Town of Brunswick, Maine

MEMORANDUM

SUBJECT: Maine Street Streetscape Project - Lemont Block Redesign

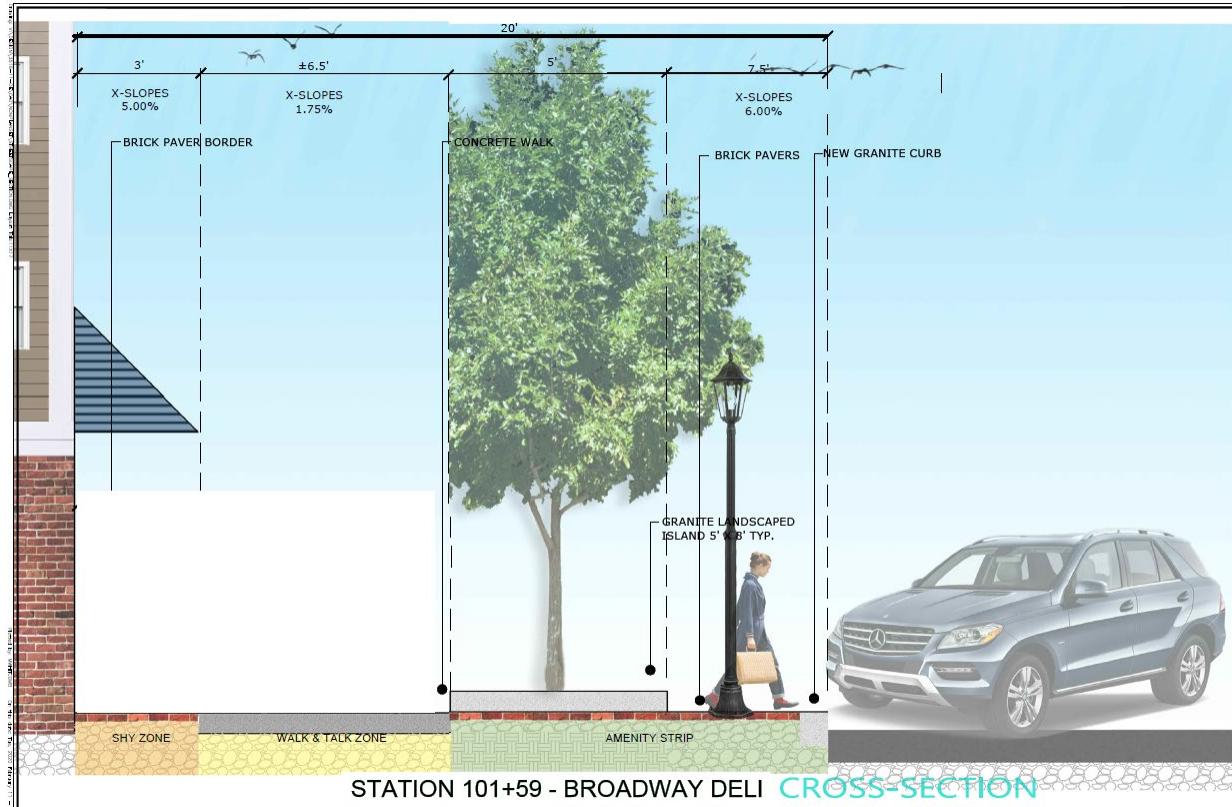
The project consultant developed a revised layout incorporating a curb bump-out. This modification significantly improves the ability to achieve ADA-compliant grades from both a technical and construction standpoint. It also increases the usable width between the curb and building faces, allowing outdoor dining and vendor space to be reintroduced along the block.

The revised curb alignment, however, necessitates the conversion of nine angled on-street parking spaces to five parallel spaces. (It is worth noting that parallel stalls are generally safer than the angled

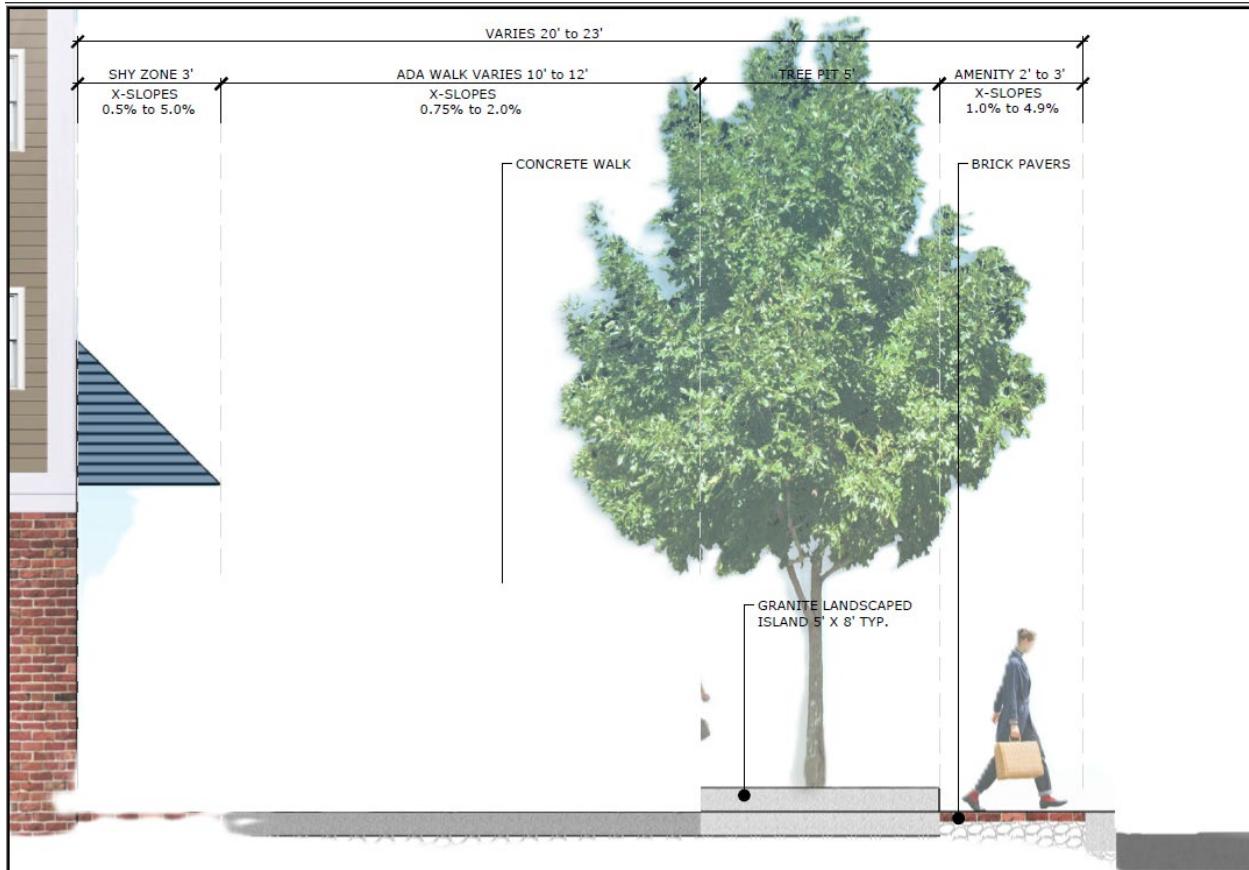
Original Design – Note only about 9 ft of space between building face and tree well/slopes back to existing grade, 5 ft of which must be reserved for ADA use. Also note high slopes next to building face and curb line.

New Design – Note about 15 ft of space between building face and tree/well slopes back to existing grade. This more than doubles the outdoor space for possible business use, while also flattening the grades along the building face and curb line.
